ADDENDUM 2

Vestavia Hill Fire Station No. 4 Expansion

DATE: **August 12, 2026**

1. FINISH FLOOR (TOP OF SLAB) ELEVATION 0'-0", UNLESS NOTED.
2. TOP OF EXISTING FOOTING ELEVATION -1'-4" BELOW FINISH FLOOR, UNLESS NOTED - FIELD VERIFY.

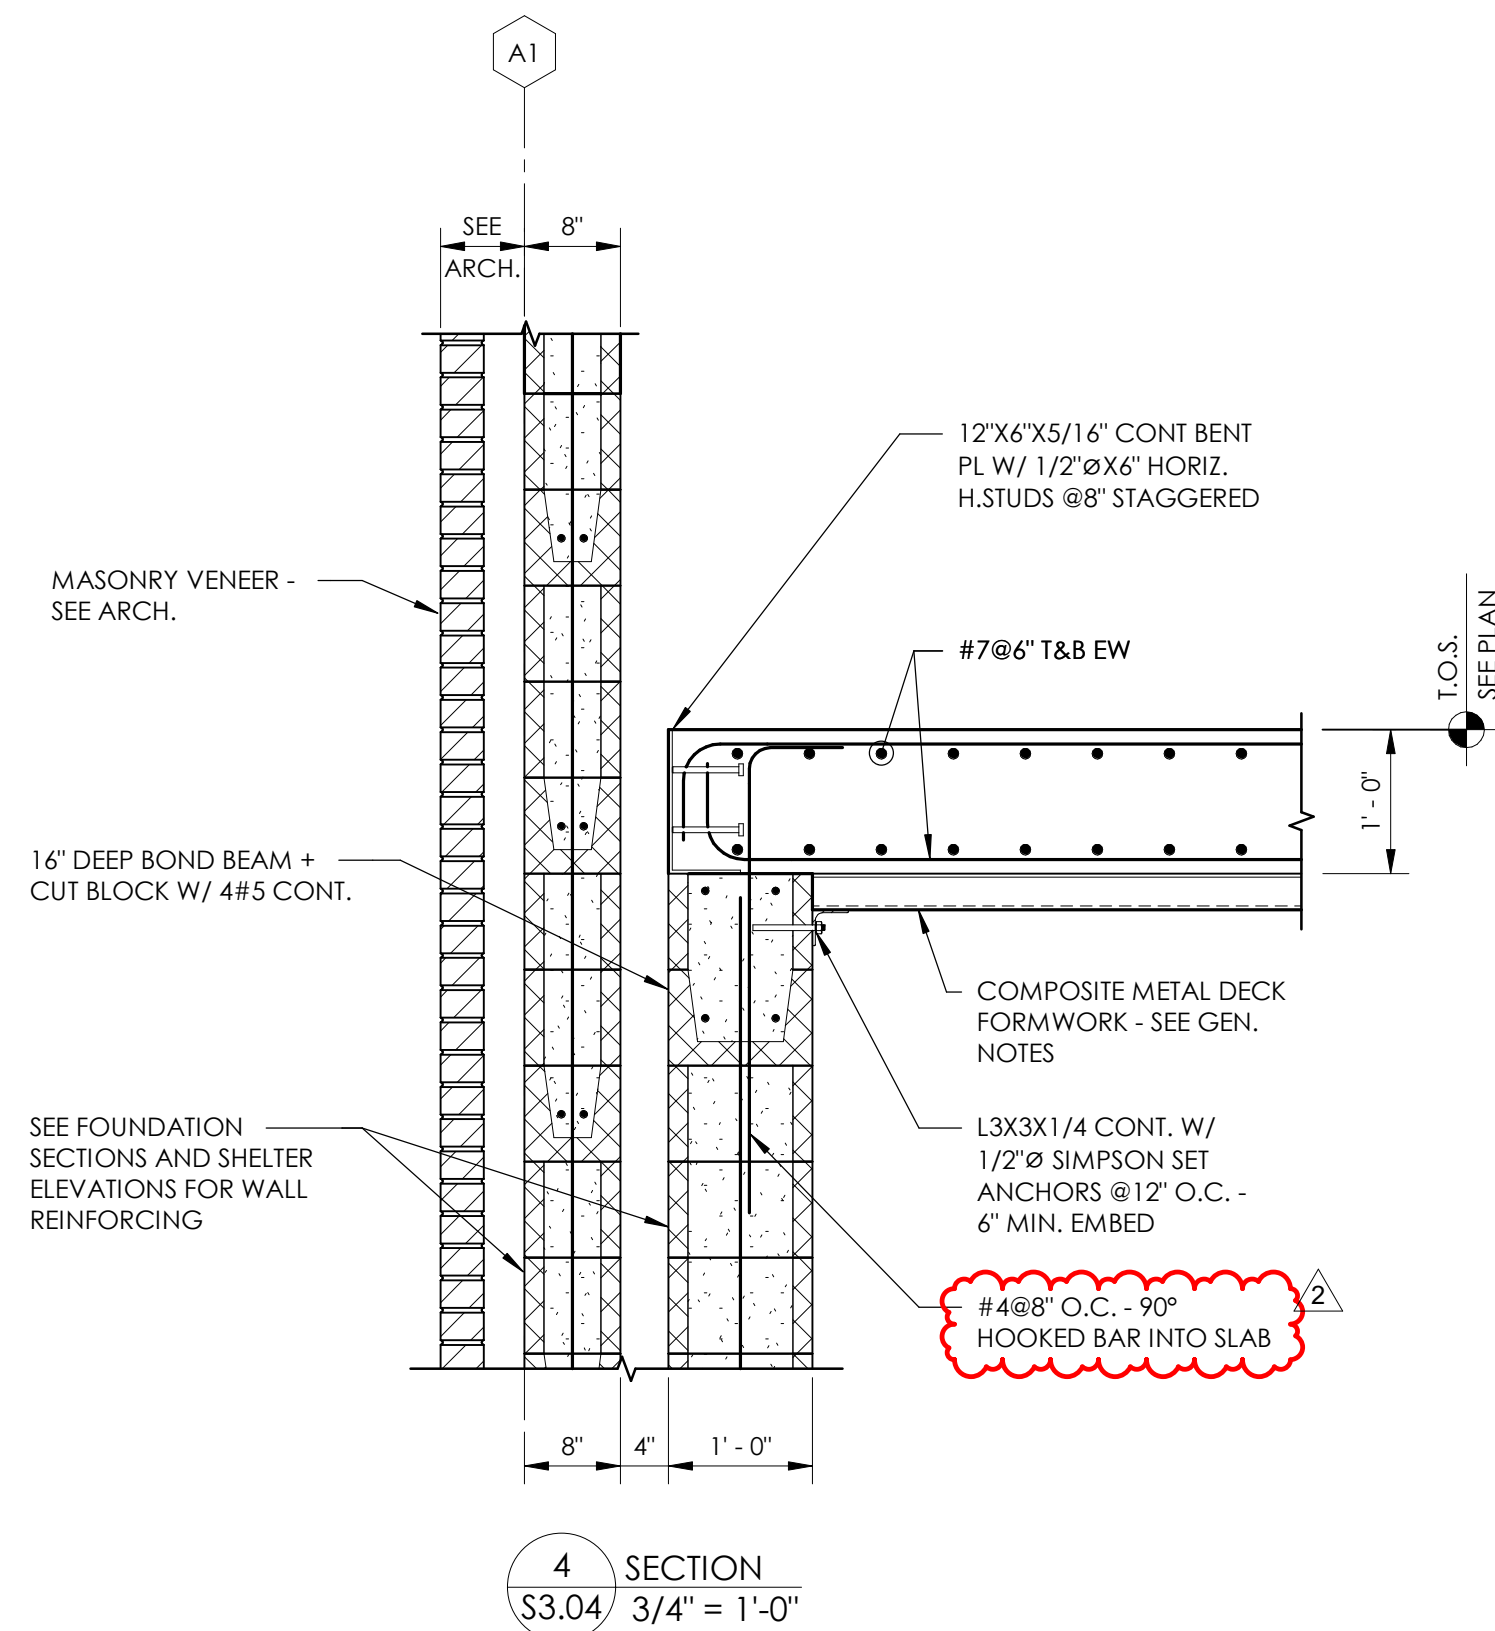
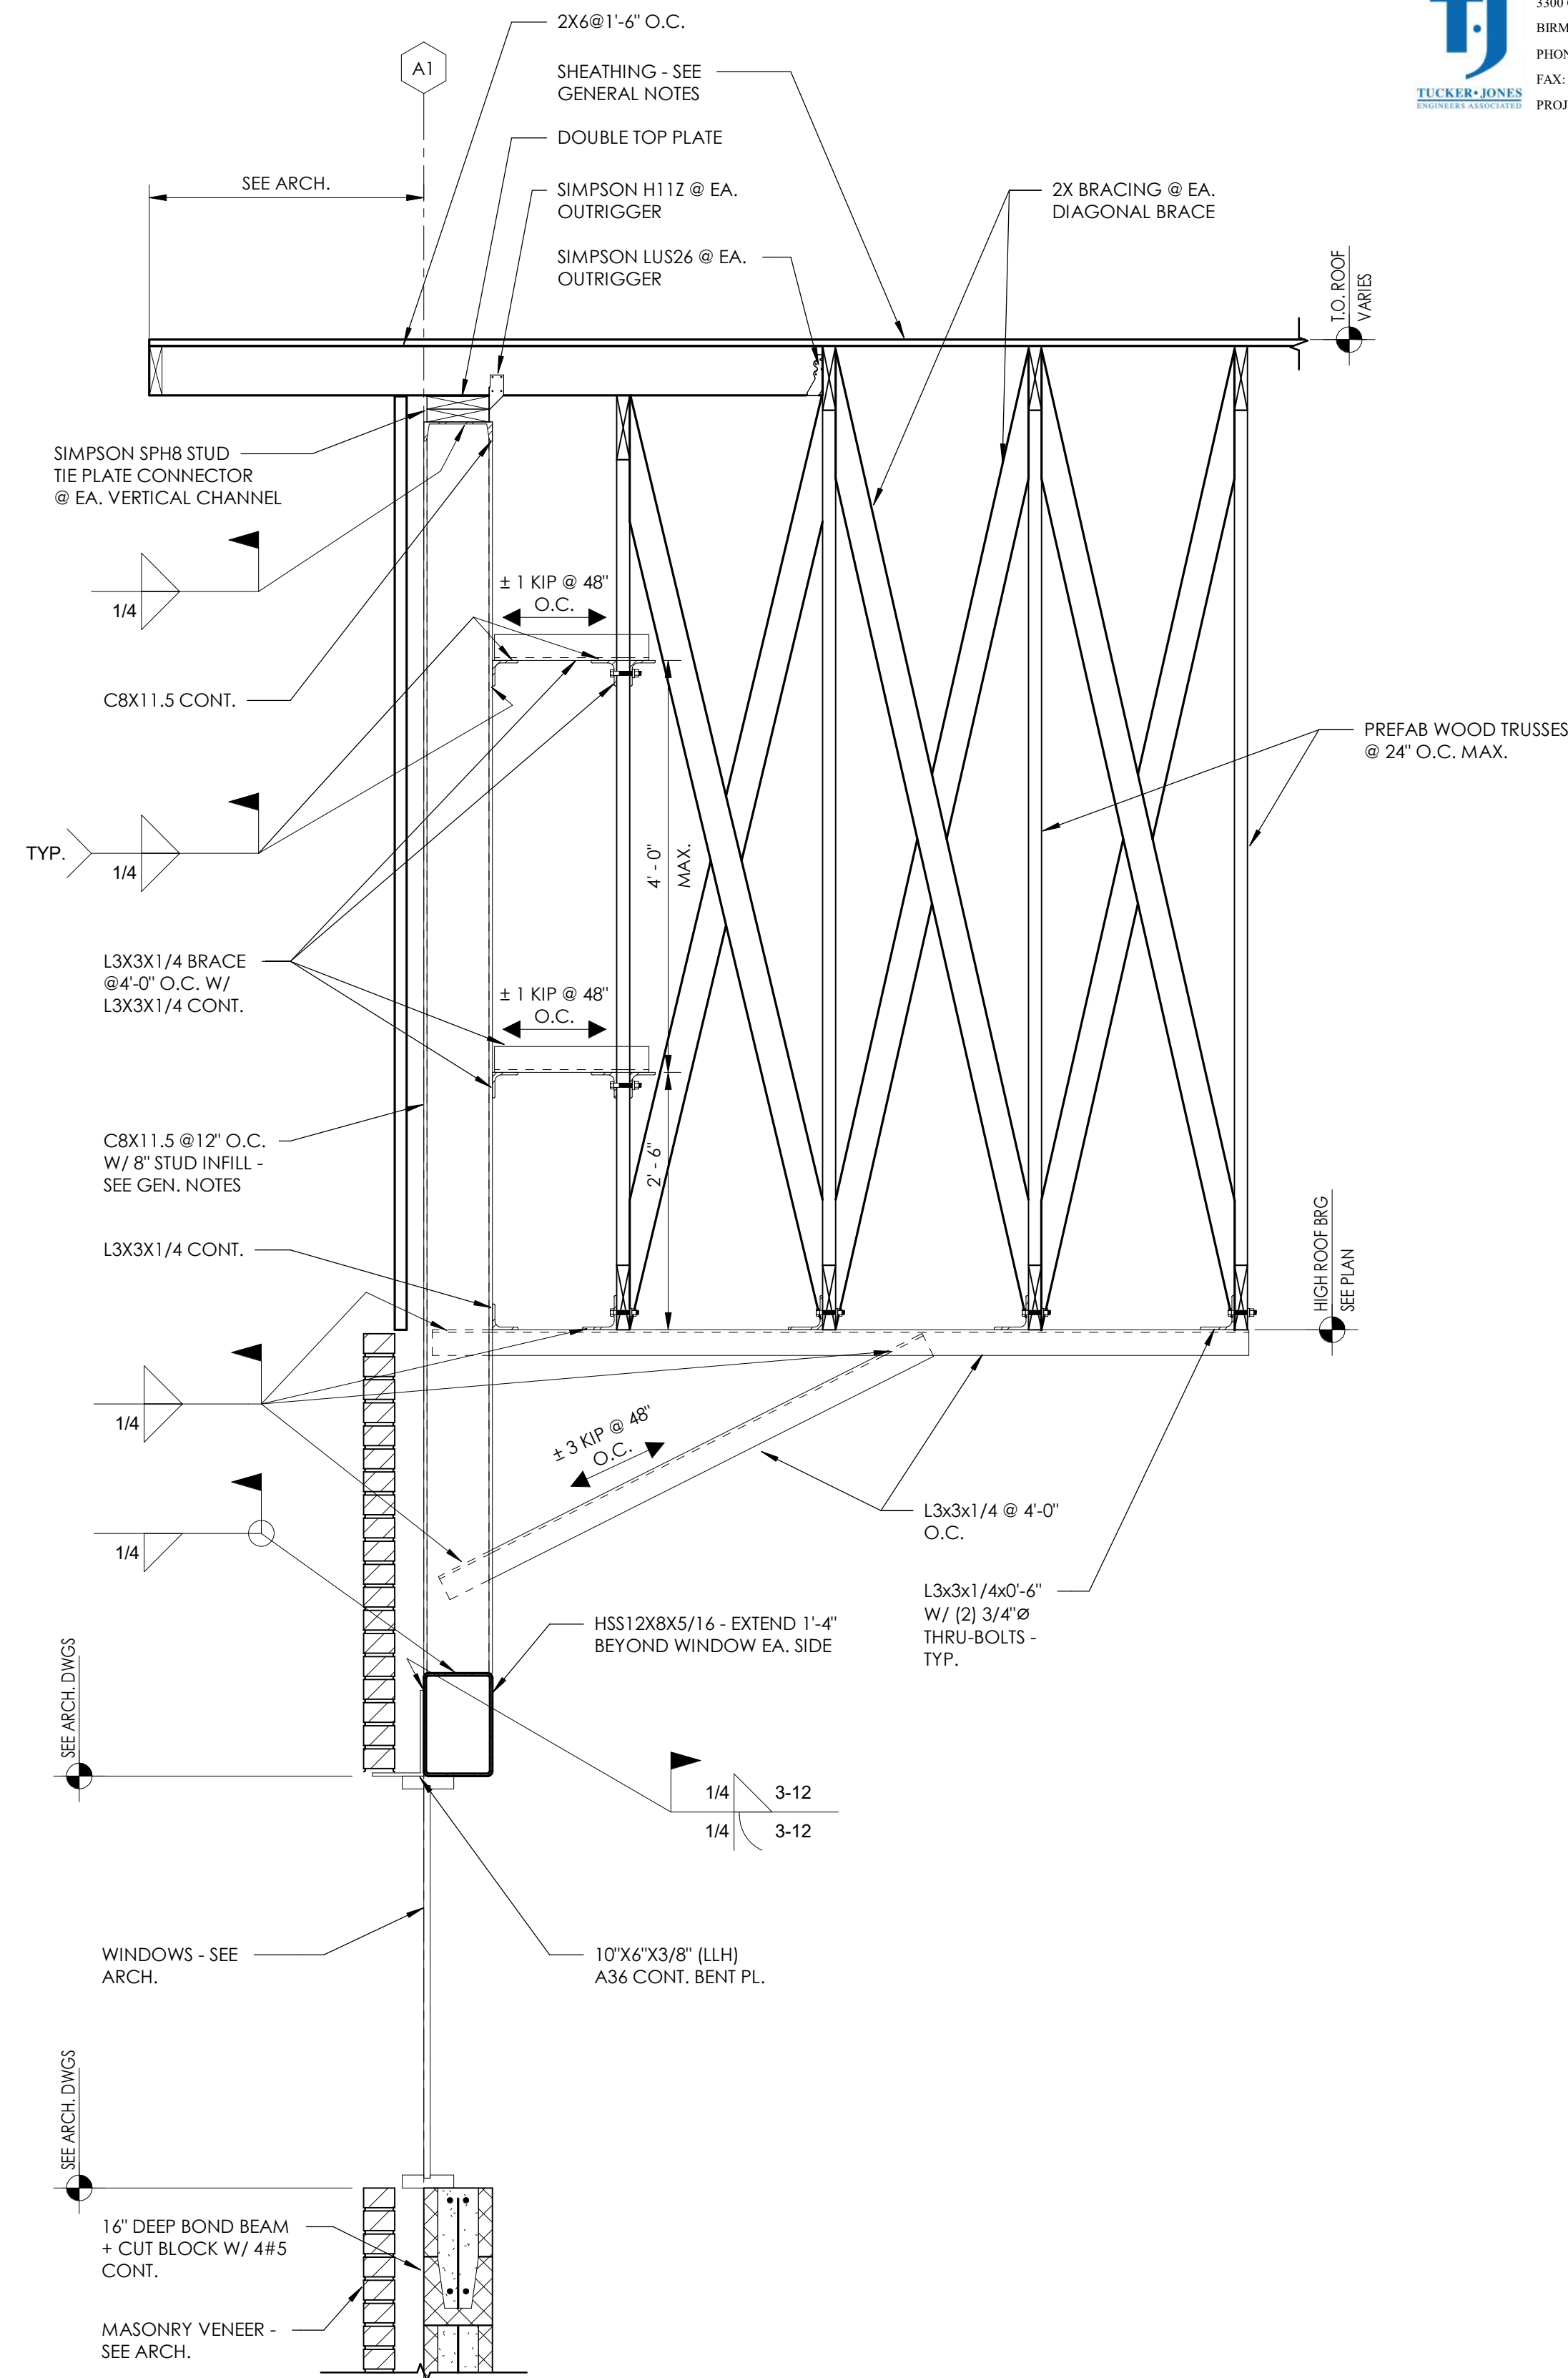
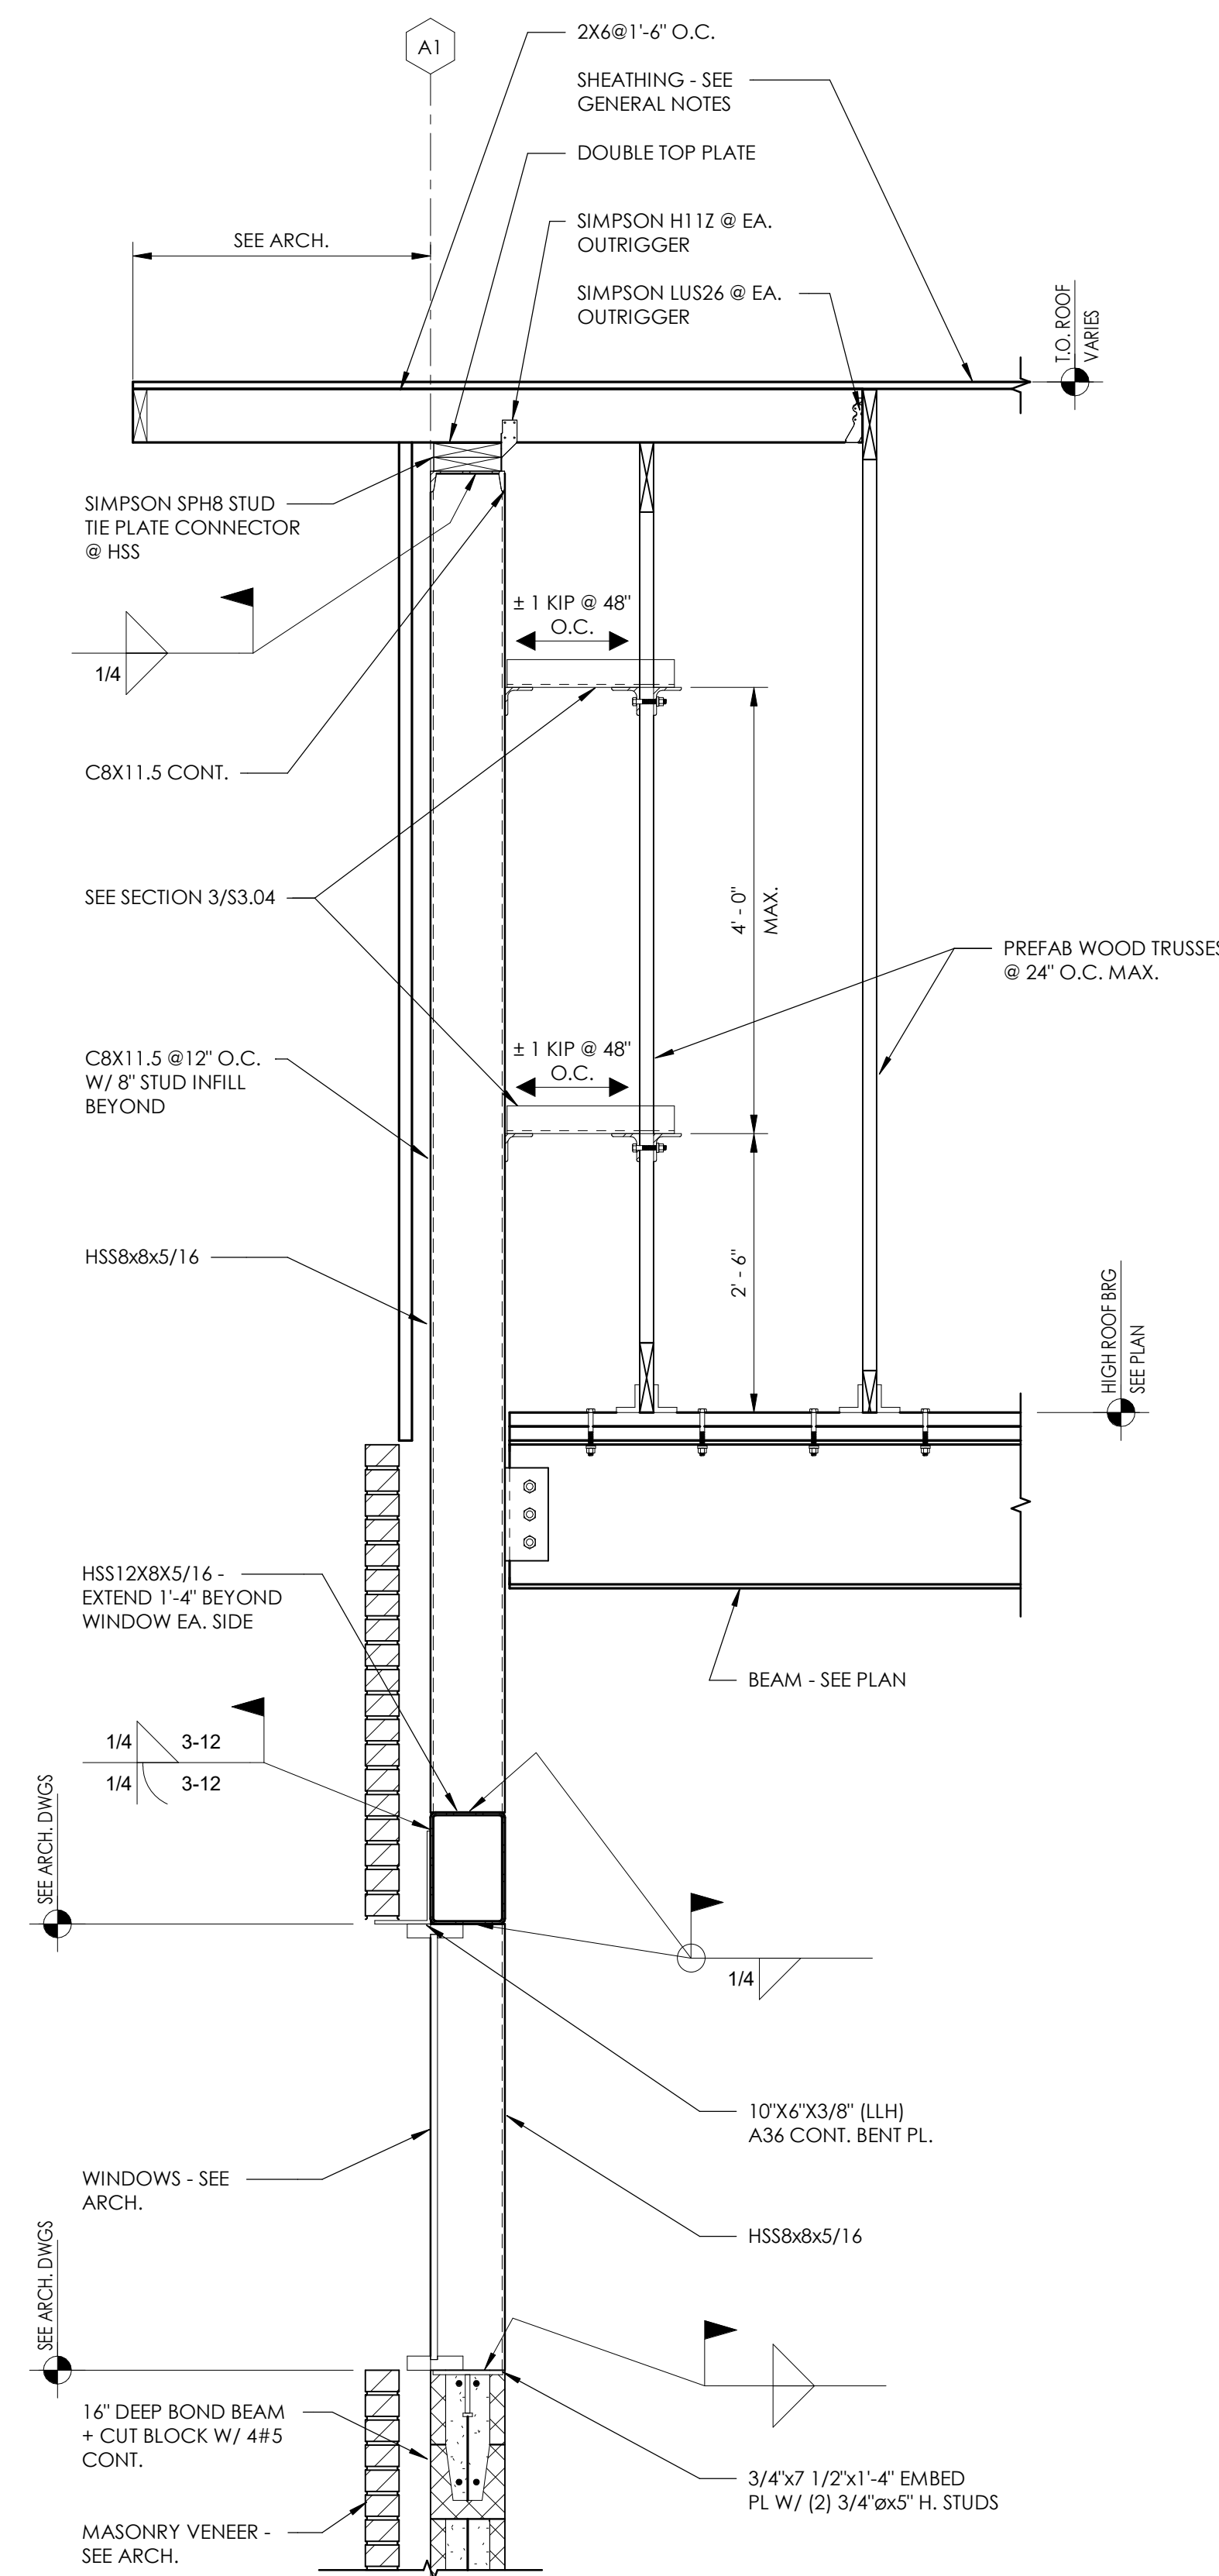
1. S1.01 – GENERAL NOTES:
 - a. General notes revised per Storm Shelter Peer Review Comments. See Revision Clouds.
2. S2.01 – FLOOR AND FOUNDATION PLAN:
 - a. “Similar” note added to sections and foundation dimensions added per Bidder RFI #1 comment received 07/13/26.
3. S3.04 – SECTIONS:
 - a. Note revised per Storm Shelter Peer Review Comments. See Revision Cloud.
